#### MEMORANDUM

Facility planning review - Chapman Avenue Extended

# Chapman Avenue Extended (CIP 509337)

Chapman Avenue Extended Phase I Facility Planning Study

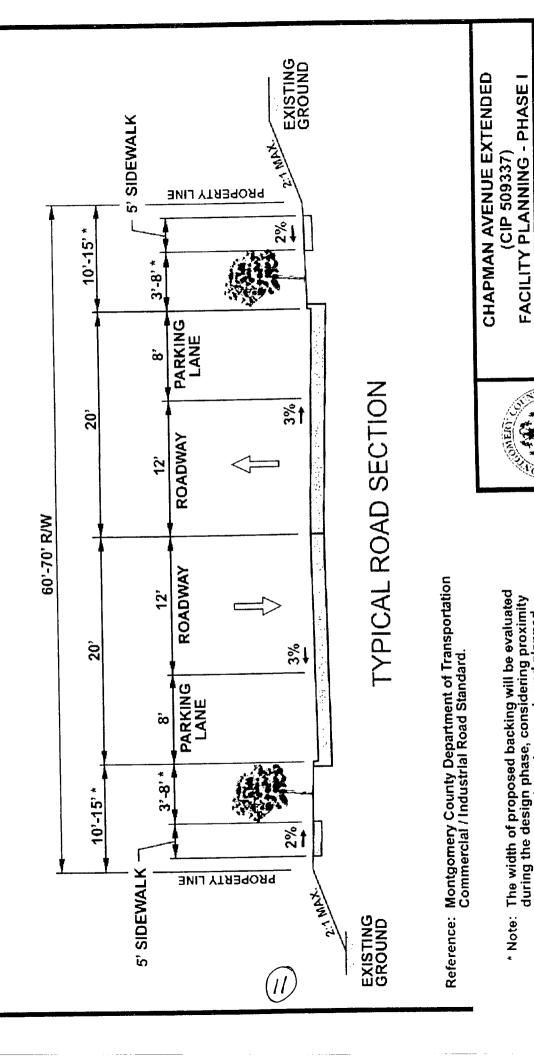
One element of Concept B deserves more investigation: the proposed intersection of Chapman Avenue with new access points to/from two parking lots northwest of the Forum Condominiums property (highlighted on ©10). As designed, these new access points would require further stops on Chapman Avenue, and making these connections would encourage cutthrough trips through these lots. This location should be redesigned to eliminate potential stops on Chapman Avenue. For example, access from Chapman Avenue to the lots might be allowed, but not vice versa.

- Set the roadway cross-section at 22': two 11' travel lanes and no on-street parking.
- Redesign Chapman Avenue northwest of the Forum Condominium property so as to eliminate any potential stop condition on Chapman Avenue at that location.

TYPICAL SECTION

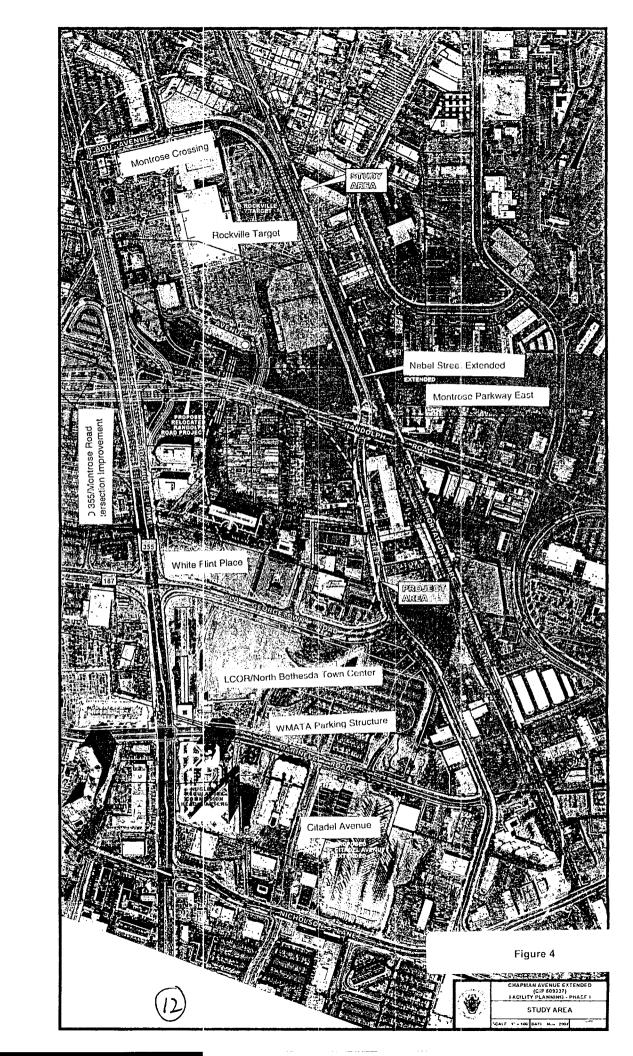
Cross-section. As noted earlier, the proposed 40'-wide roadway shown on ©11 is standard for a business district street. However, given the cost and impact of right-of-way, the need for this much pavement should be scrutinized closely. First of all, considering its low speed and moderate volume, 11'-wide lanes would suffice, even in the Maple Avenue segment, which is zoned I-4 and serves industrial uses. More importantly, there is little evidence that on-street parking is necessary north of the Windsor Villa Apartments. There is no on-street parking on Maple Avenue, there is no access from the Forum Condominiums, and the other adjacent shopping centers (also zoned I-4) have plentiful off-street parking. The section of Chapman Avenue through Montrose Crossing—just north Randolph Road—also has no on-street parking.

Constructing Chapman Avenue Extended with 11'-wide travel lanes and without onstreet parking would reduce the roadway width from 40' down to 22'. Reducing the pavement width by 18' and exercising flexibility with the width of the landscape panel would allow DPWT both to reduce the construction cost and right-of-way impacts, as well as to virtually eliminate the increase in impervious surface. Furthermore, a 40'-wide street will produce higher travel speeds (especially when there would be few if any parkers—most of the time) than would a 22'-wide street.
